2ND STREET APARTMENTS

501 2ND STREET NE, PUYALLUP, WA 98372

PERMIT REVIEW SET

ISSUED PERMIT

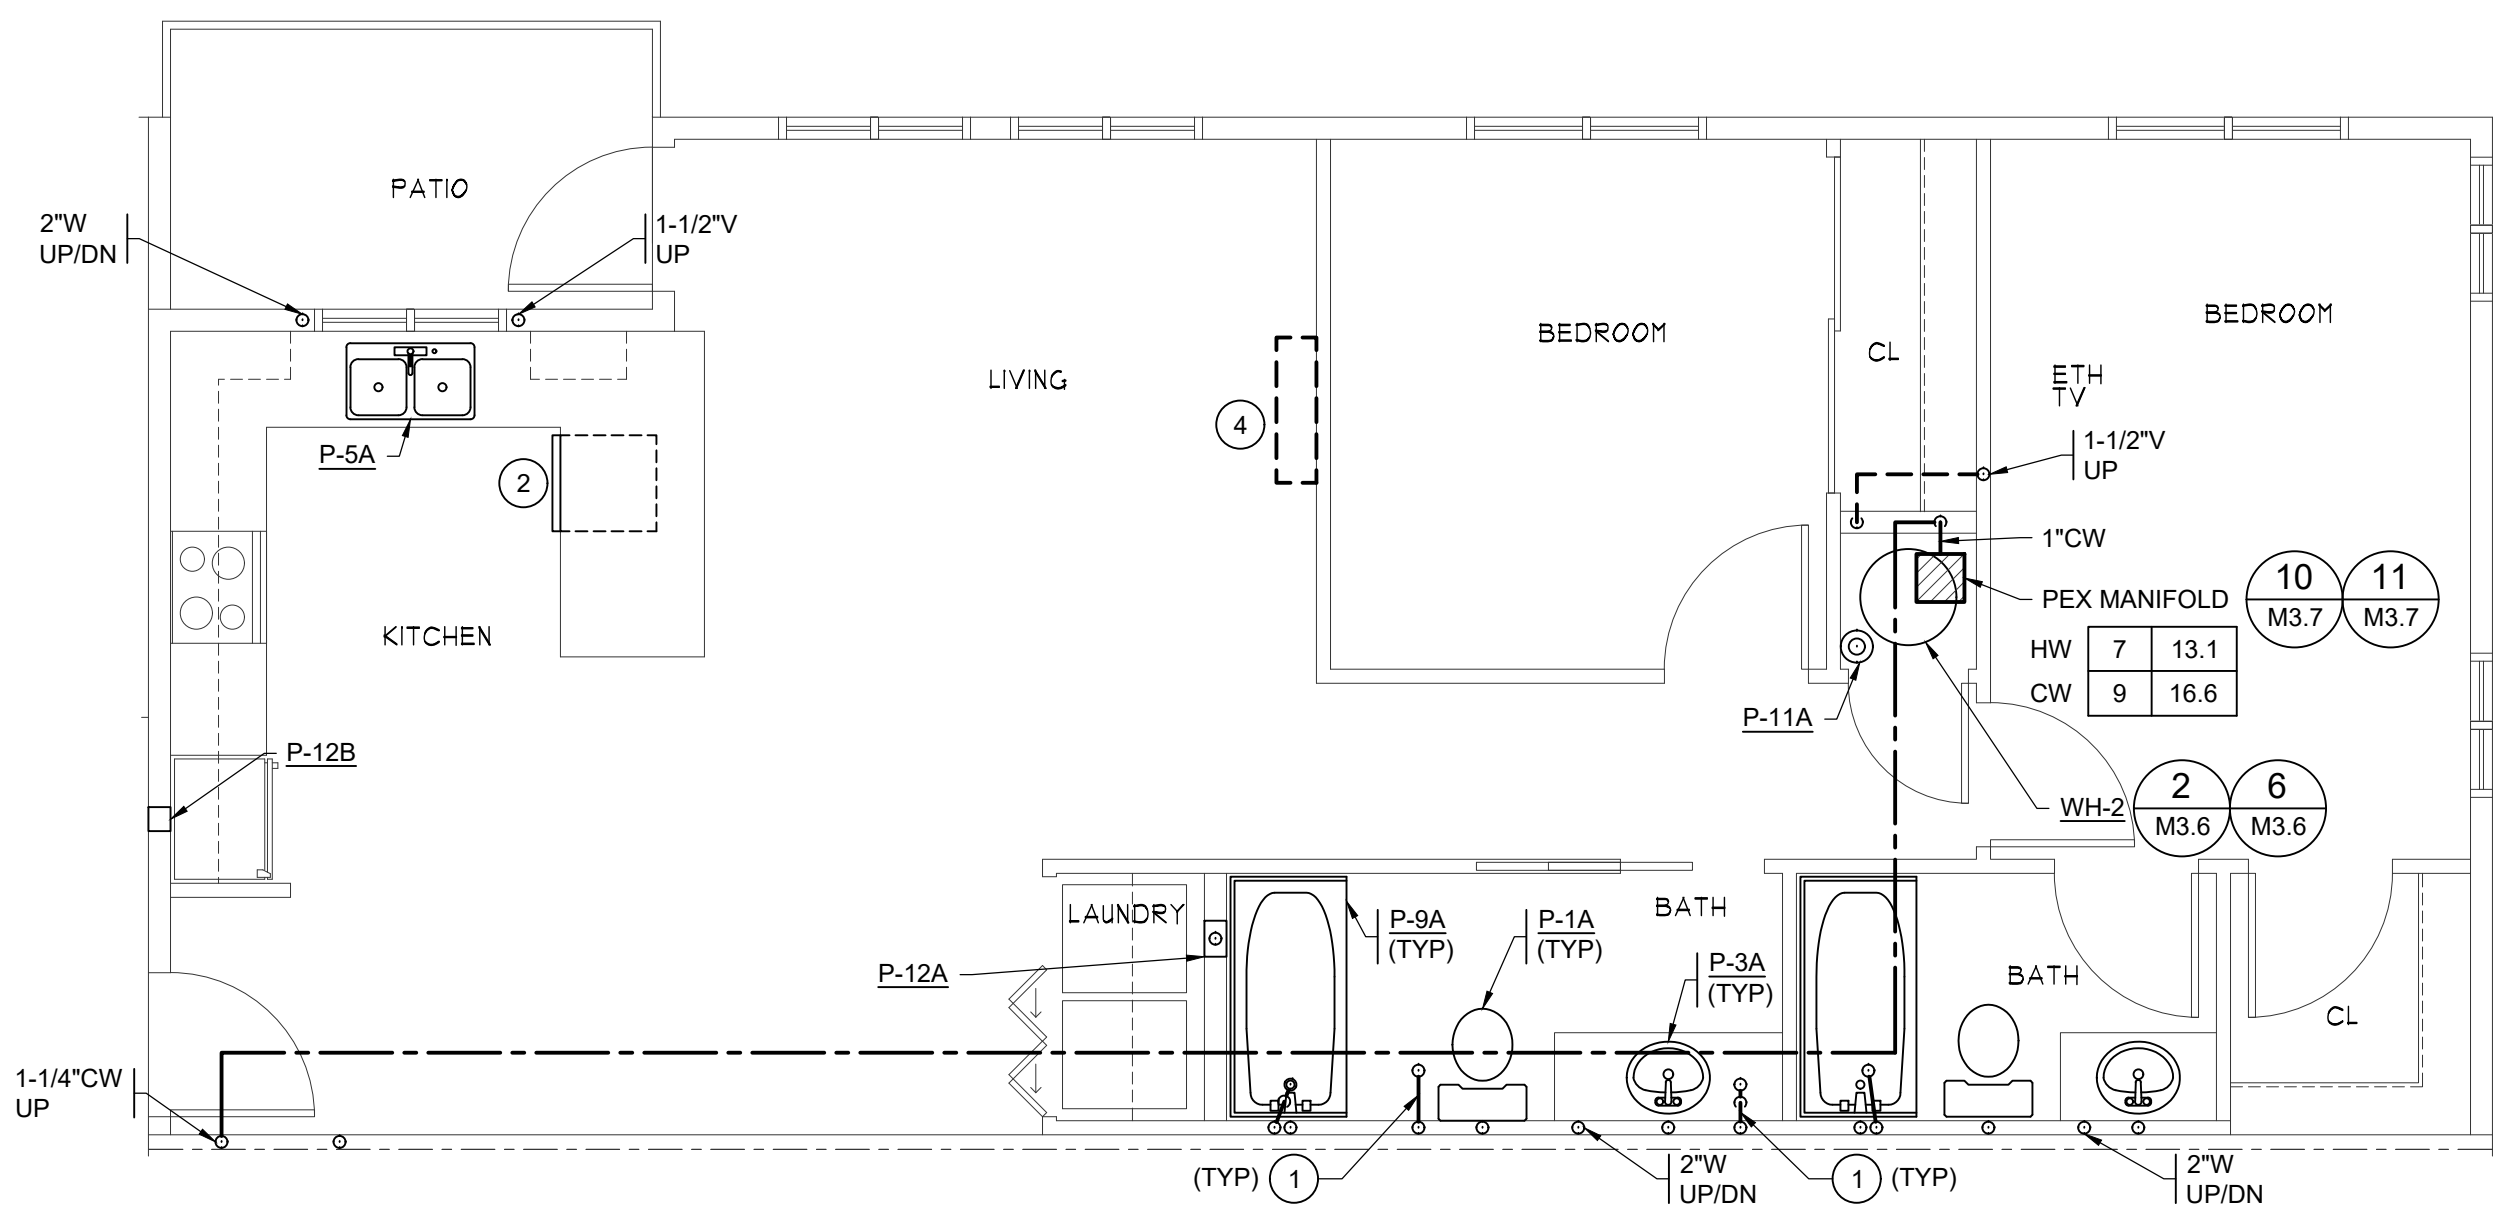
Building
